ADDENDUM #06

TO INVITATION TO BID #01

POLICE HEADQUARTERS 33 LAUREL STREET BRANFORD, CT 06096

October 24th, 2024

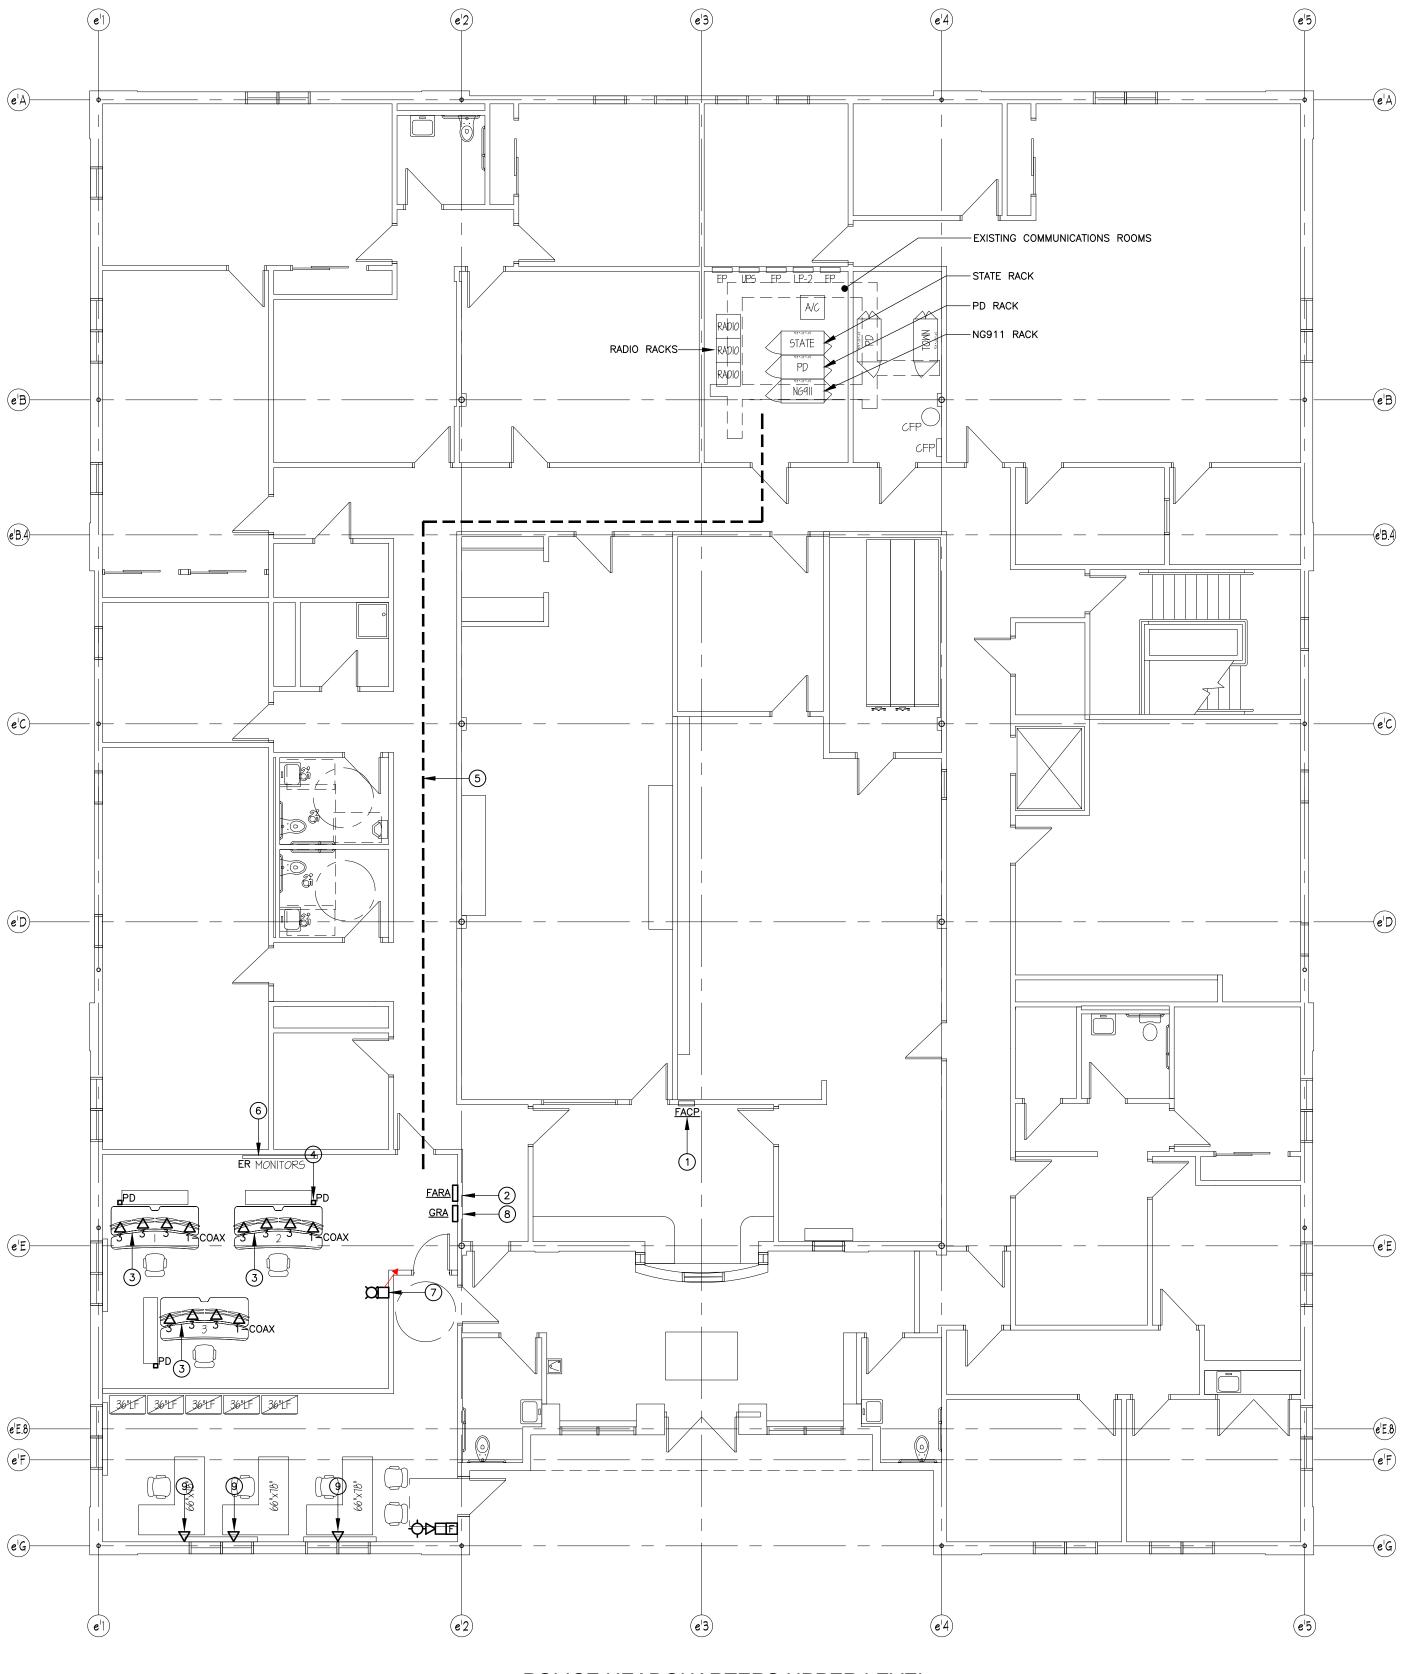
Question - 5. Addendum No. 4 paragraph 12 says that Bid Package #9.1 Gypsum Drywall should incorporate the following additional scope of work: "70. This subcontractor shall be responsible to patch existing walls where any existing electrical or data are identified to be removed and reinstalled as indicated on the MEP demolition drawings and as also shown by their new work symbols as much of the upper floor walls are existing to remain."

- a. For MEP removals in existing drywall partitions, is BP 9.1 responsible to patch/infill all of the wall openings, regardless of size, that occur as a result of the demolition?
- b. For new MEP penetrations in existing drywall partitions:
- i. Is BP 9.1 responsible to cut all openings in existing drywall partitions, or will the MEP trades be responsible to cut small openings that occur between the existing metal studs?
- ii. Will the MEP trades be responsible for sealing and/or fire rating their penetrations?

Answer - a. - Yes. Assume 1' strip for removal of strip for existing demo/new re-work of electrical/data.

- b. MEP trades responsible for penetrations through existing walls as noted in their respective cutting/patching scope notes as well as sealing/fire rated of these penetrations.
- JVMV (DCC) 10.24.24

TEMPORARY
ELECTRICAL
PLANS AT
POLICE
HEADQUARTERS

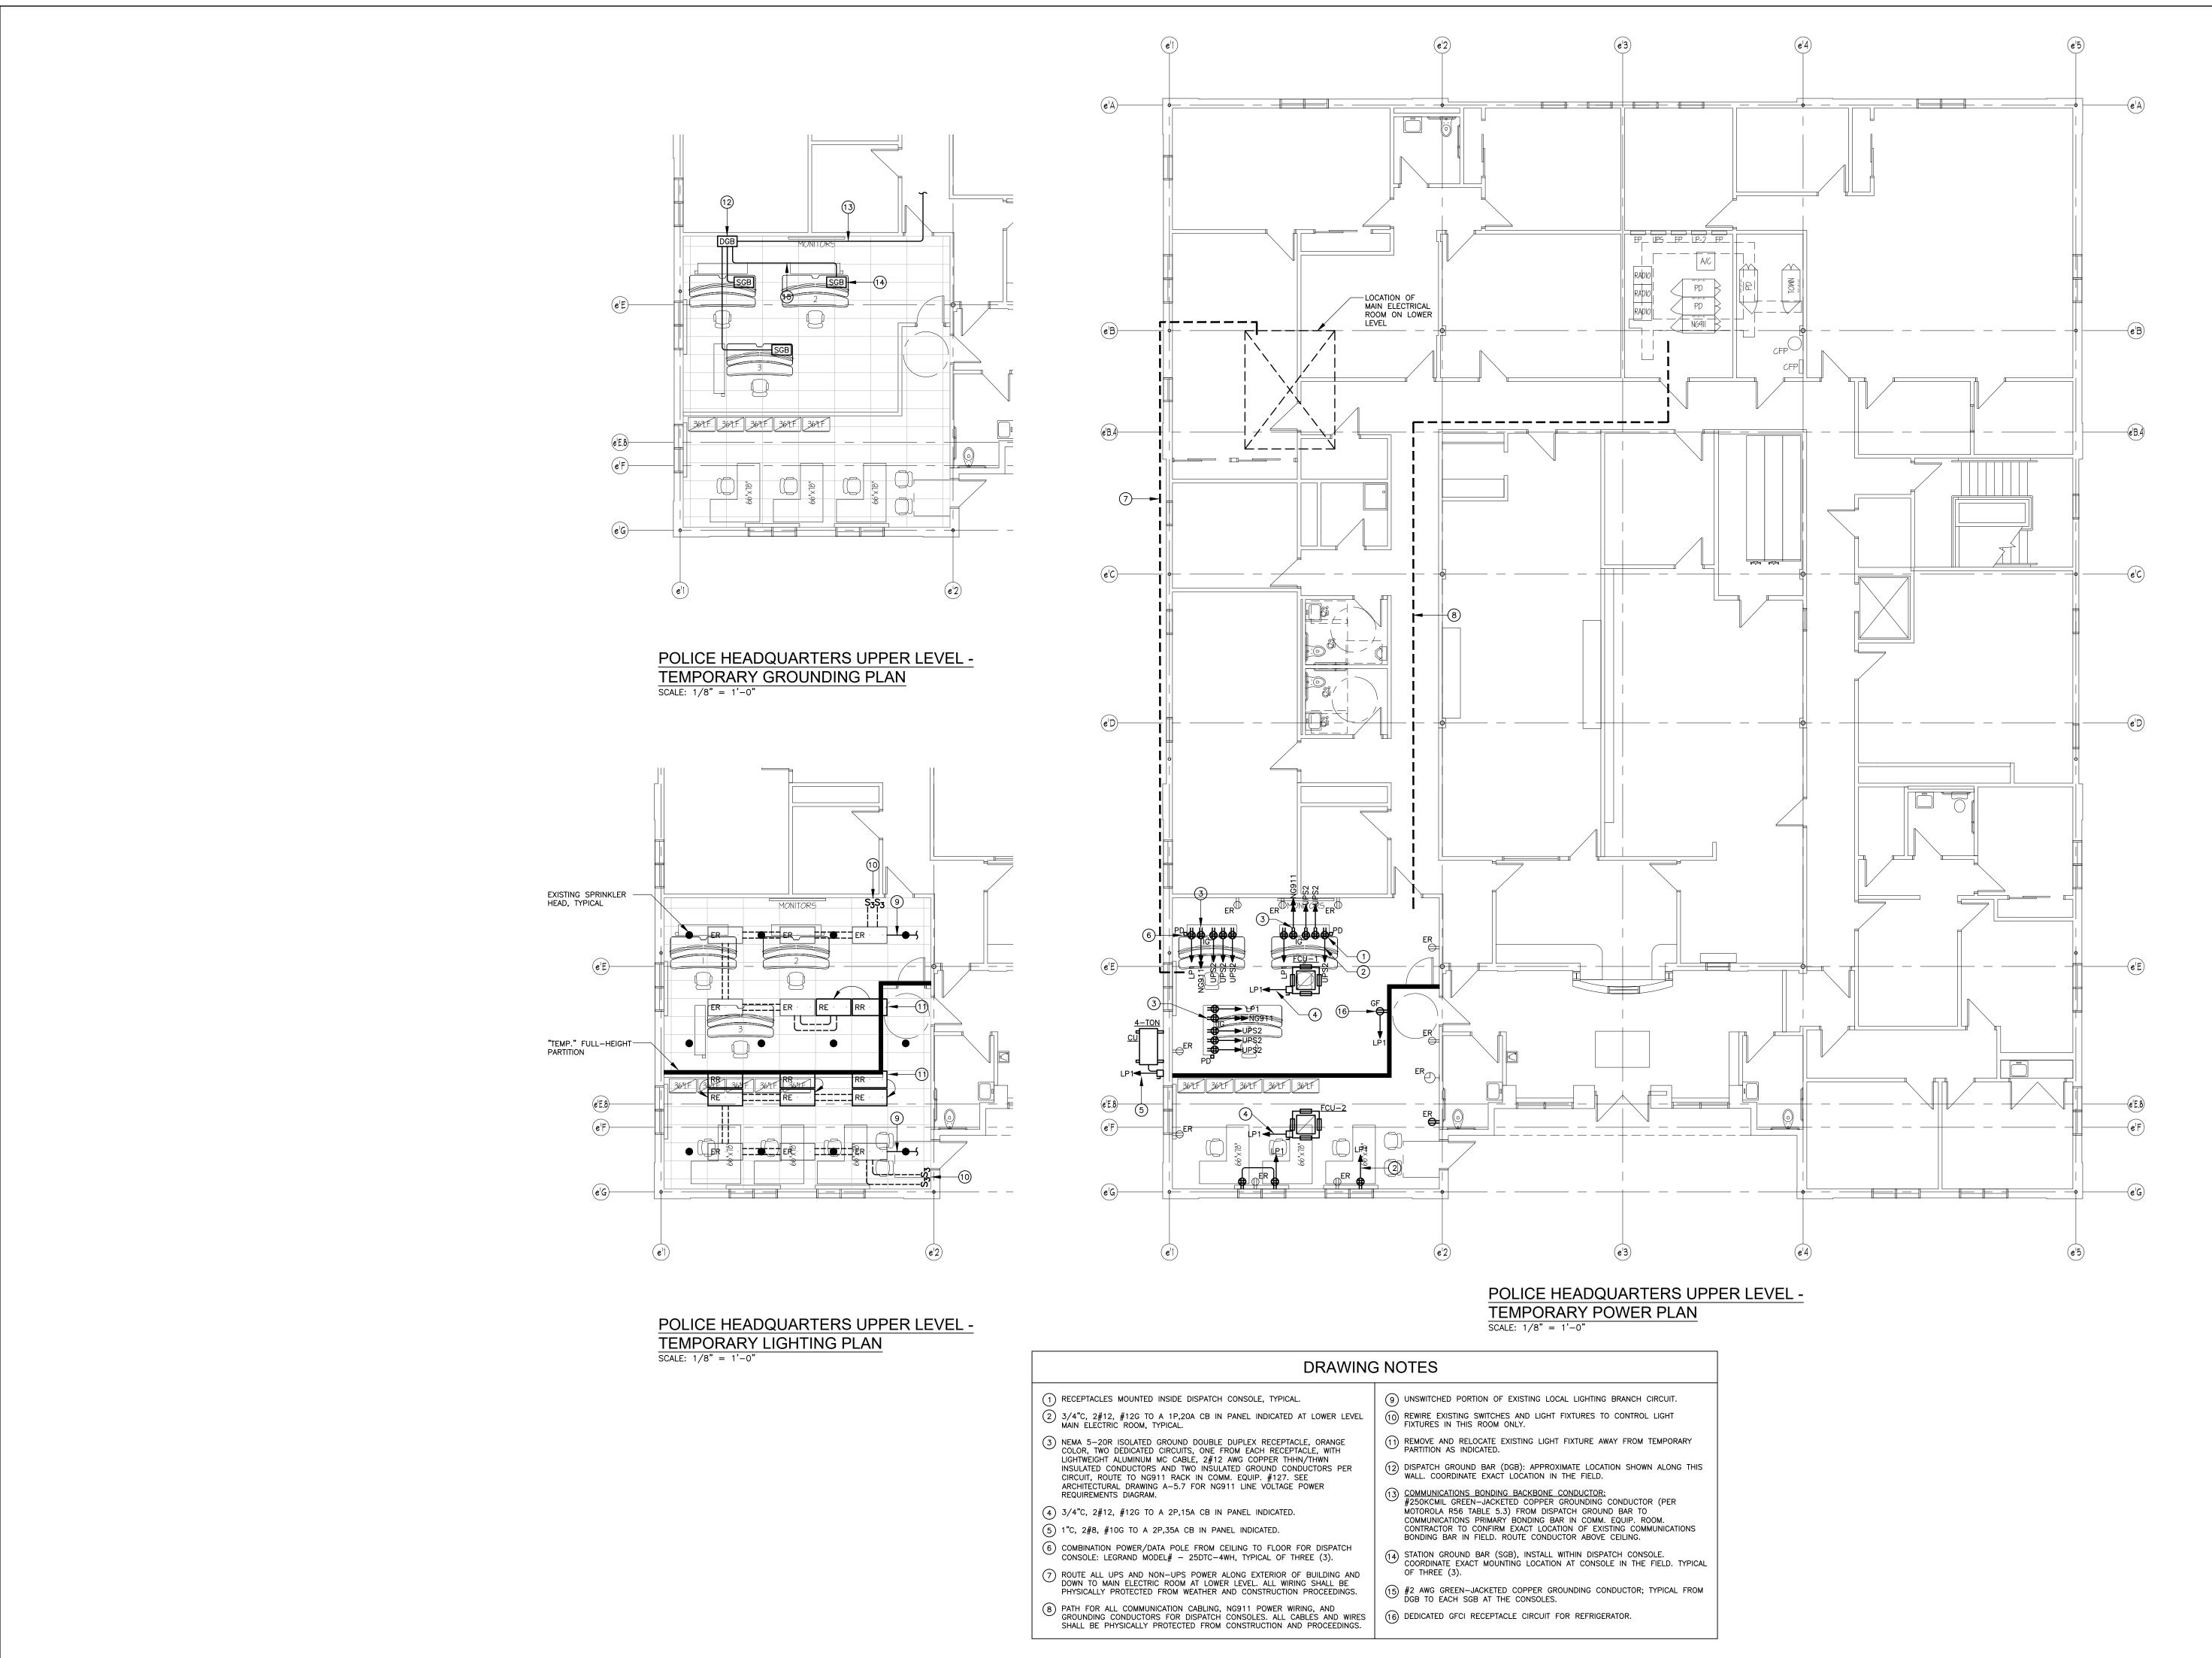
- a. Provide/maintain data, power and lighting to devices in these enabling spaces as shown. Coordinate power/data poles on TE1.1 within acoustical ceilings.

TEMPORARY SITE ULITITY **PLANAT POLICE HEADQUARTERS**

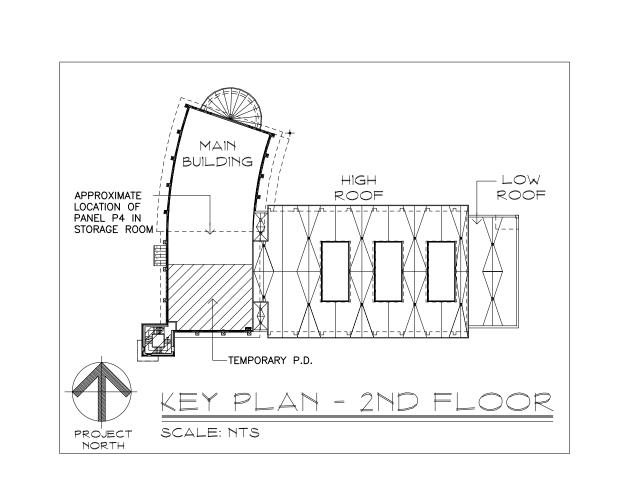
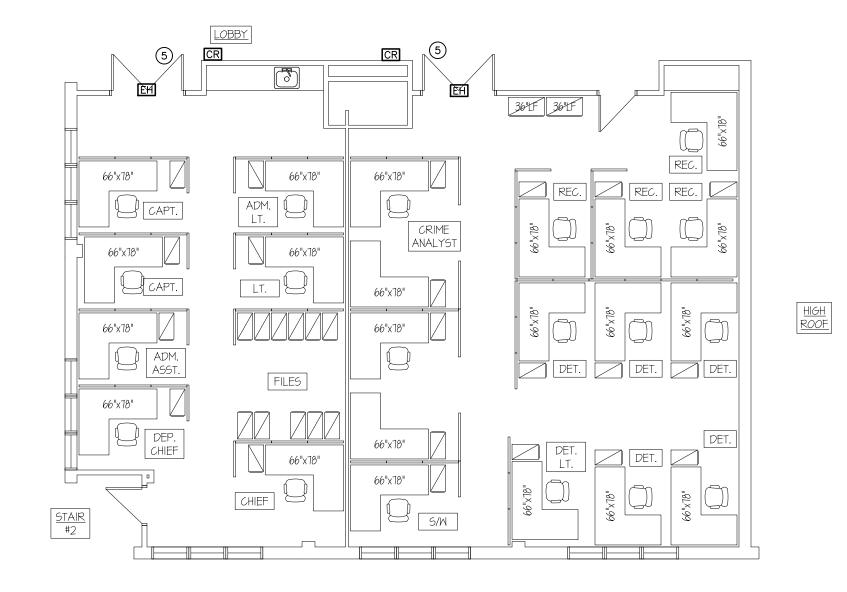
- 115. This subcontractor shall be responsible to provide and install the fiber, fiber optic transceiver and NEMA 3R heat rated enclosures as identified on SU1.0 note 19 as well as for any other cameras denoted on this site utility plan. Camera to be installed by BP #28.1.

- Assume MEP coordination around elements of this existing system(s) to remain.
- 93. This subcontractor shall be responsible to provide and install the camera identified on SU1.0 note 19 as well as any other cameras denoted on this site utility plan. Fiber cabling and enclosure noted to be provided by BP #26.1.
